ENGINEER'S SEAL DAVID SOULE NEW MEXICO 14522 REGISTERED PROFESSIONAL ENGINEER 7/13/22 DAVID SOULE P.E. #14522	LOT 33 BLK 8 UN 5 VC 7900 MARIGOLD DR	DRAWN BY DEM
	GRADING AND DRAINAGE PLAN	DATE 7-12-22
	 Rio Grande Engineering P.O. BOX 53924 ALBUQUERQUE, NM 87199 (505) 321-9099	SHEET # C1 JOB #

DRAINAGE AND TRANSPORTATION INFORMATION SHEET (REV 6/2018)

RE: **Lot 33 Block 8 Unit 5 SAD 227
7900 Marigold Dr. NW
Volcano Cliffs Subdivision
Grading and Drainage Plan
Engineers Stamp Date 7/13/2022 (E10D120)**

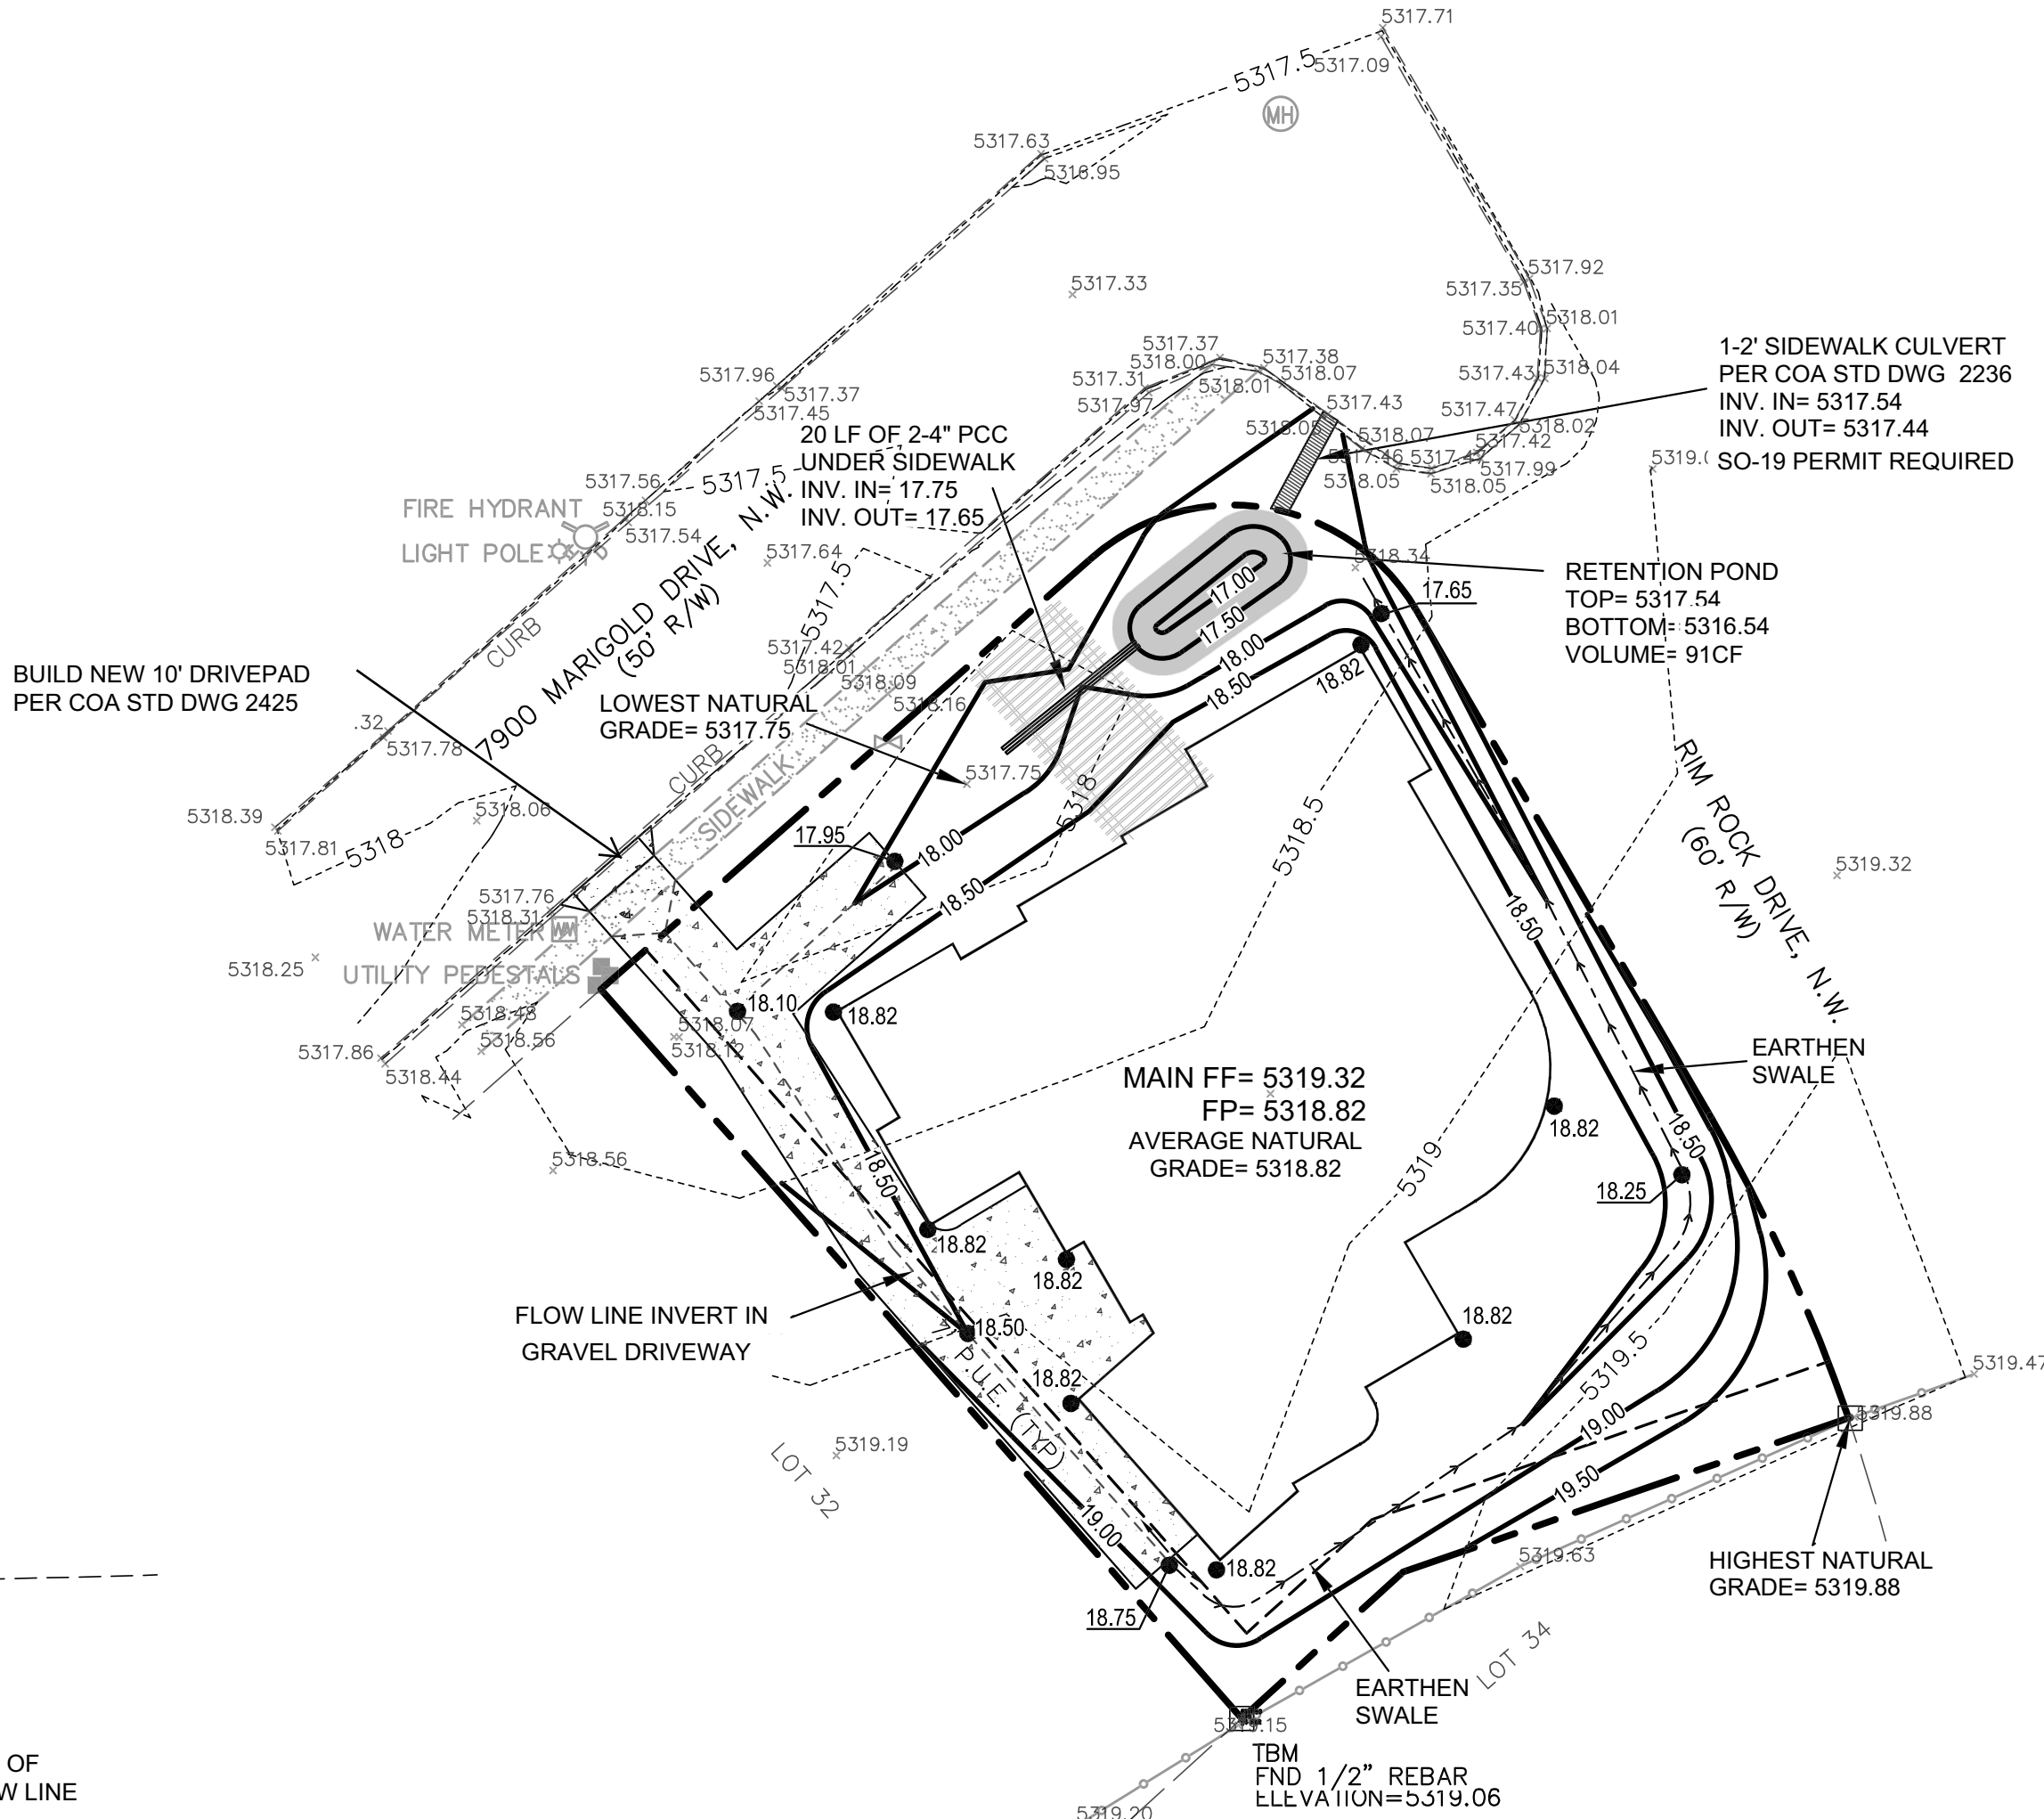
Based upon the information provided in your submittal received 7/14/2022, this plan is approved for Grading Permit and SO-19.

Prior to Building permit approval a Pad Certification will be required, provided by the Engineer or a registered Land Surveyor.

Advise the owner contractor not to use dirt as a ramp to climb the curb, use lumber or crusher fines for this purpose. Place this note on the plan.

Reiterate to the Owner/Contractor that a separate permit for a garden/retaining wall must be obtained with the approved G&D plan and Pad Certification. Also, if a swimming pool is to be placed after this approval a new grading and drainage plan will need to be resubmitted showing the changes for the land treatments.

Prior to Certificate of Occupancy release, Engineer Certification per the DPM checklist is required.
